CHANGE ORDER NO 1 (#2014.035)

Project: Virginia Large Crossing Project		Owner: Douglas County – Public Works	Owner's Contract No.: NA
Contract:	PWP-DO-2014-044	Date of Contract:	January 9, 2014
Contractor:	Herback General Engineering	Engineer's Project No.:	0110-104

JOB: Virginia Canal Crossing

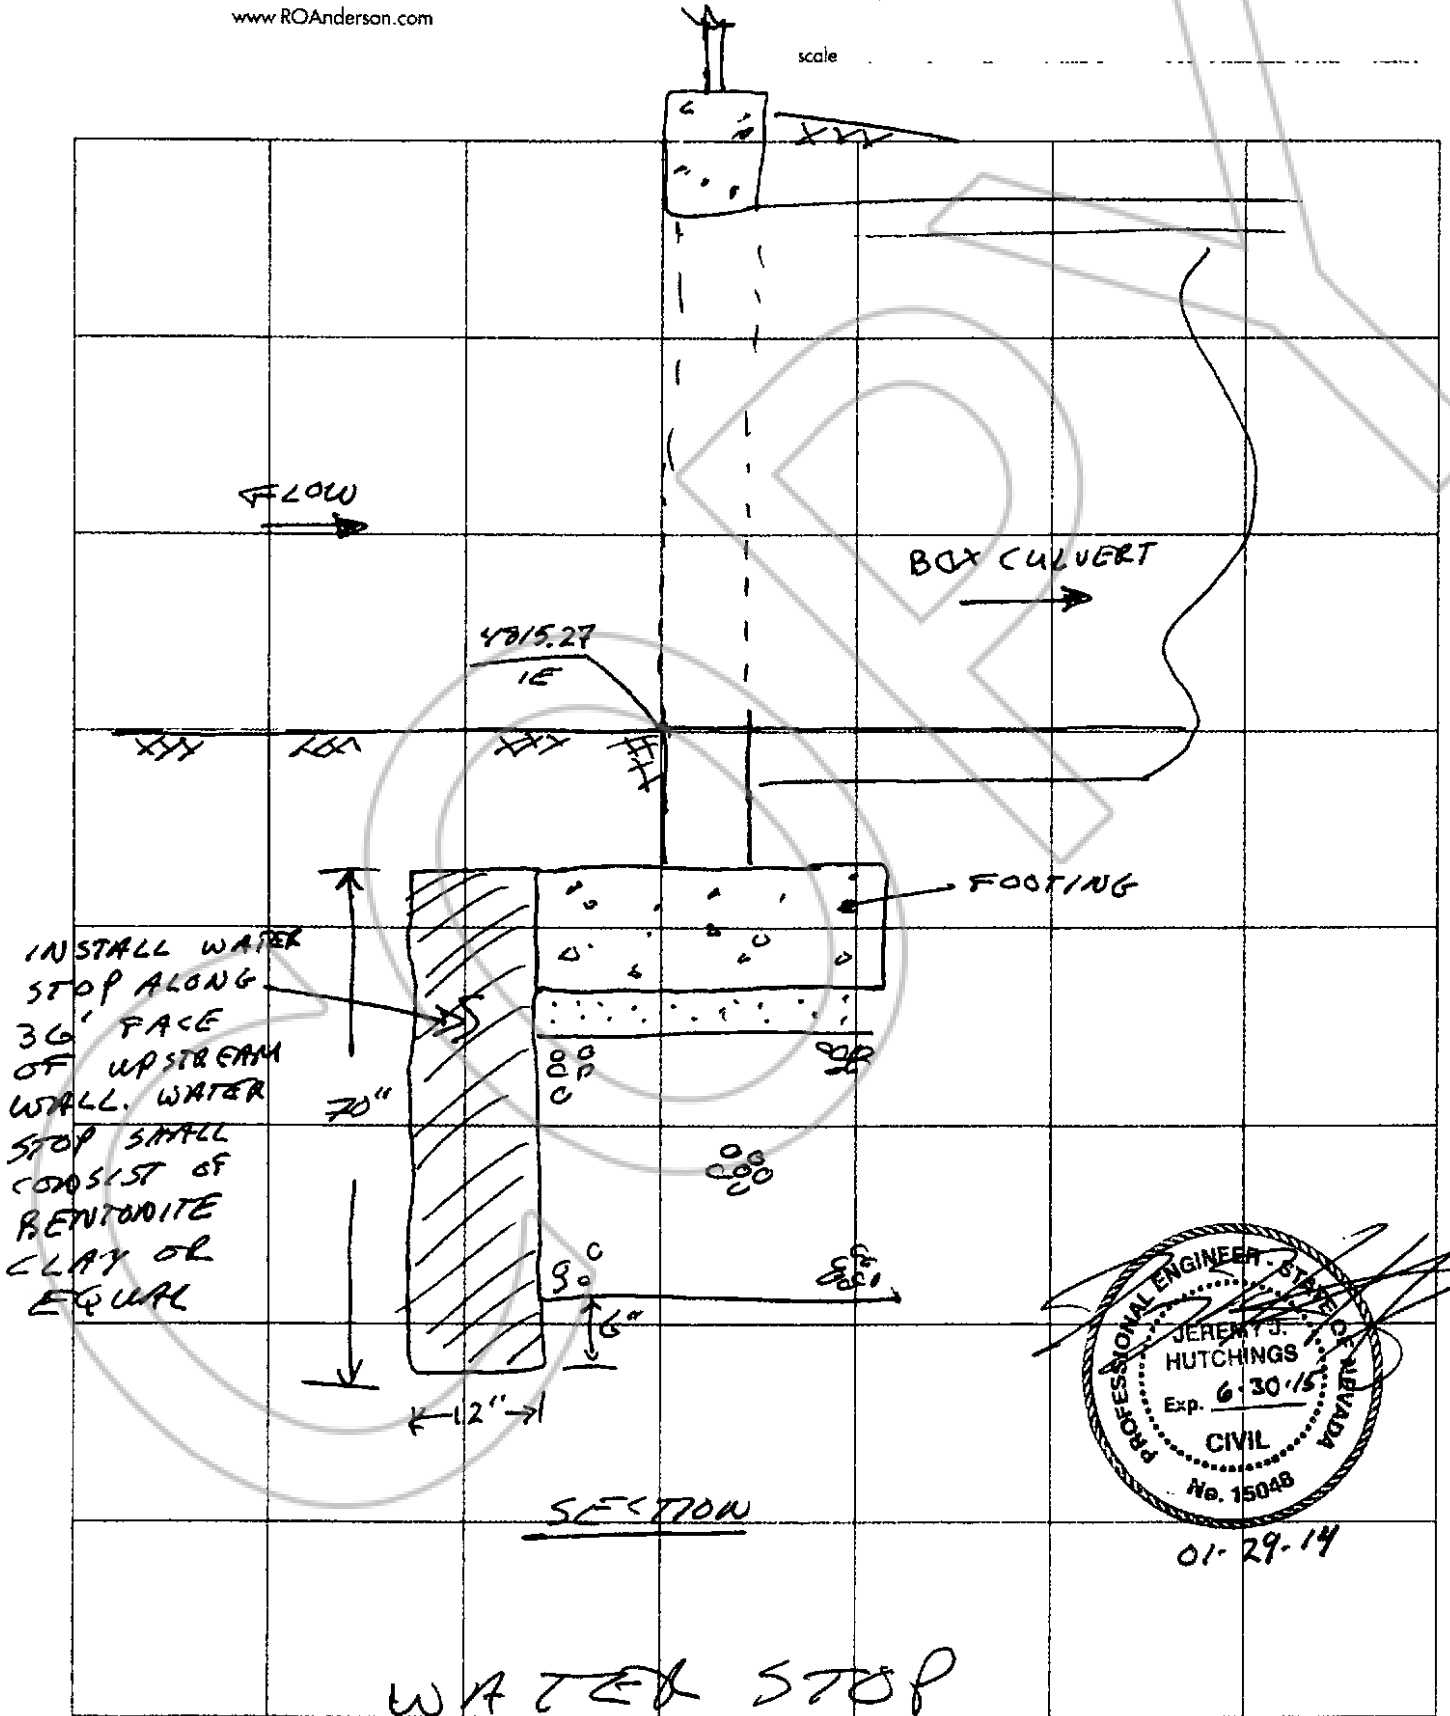
Description: Install water stop along 36' face of upstream wall. Water stop shall consist of a 3 Sack Cement Sand Slurry Mix.

- Notes:**
- PROPOSAL PRICING IS CONSISTANT WITH VIRGINIA CANAL CROSSING " WATER STOP" DETAIL DATED 1/22/2014 BY RO ANDERSON WHICH SPECIFIES EXCAVATION/ INSTALLATION OF A WATER STOP ON THE UPSTREAM CULVERT FACE (30'L X 6'D X 1'W). PROPOSAL PRICING INCORPORATES USE OF A 3 SACK CEMENT SAND SLURRY MIX IN LIEU OF BENTONOTE CLAY.
 - PROPOSAL PRICING ASSUMES DISPOSAL OF ALL EXCAVATION SPOIL ON SITE.
 - PROPOSAL PRICING ASSUMES ALL WORK IS TO BE PERFORMED IN CONJUNCTION WITH VIRGINIA CANAL CULVERT WORK CURRENTLY UNDER CONTRACT; PROPOSAL IS VOID AS A STAND ALONE WORK SCOPE.
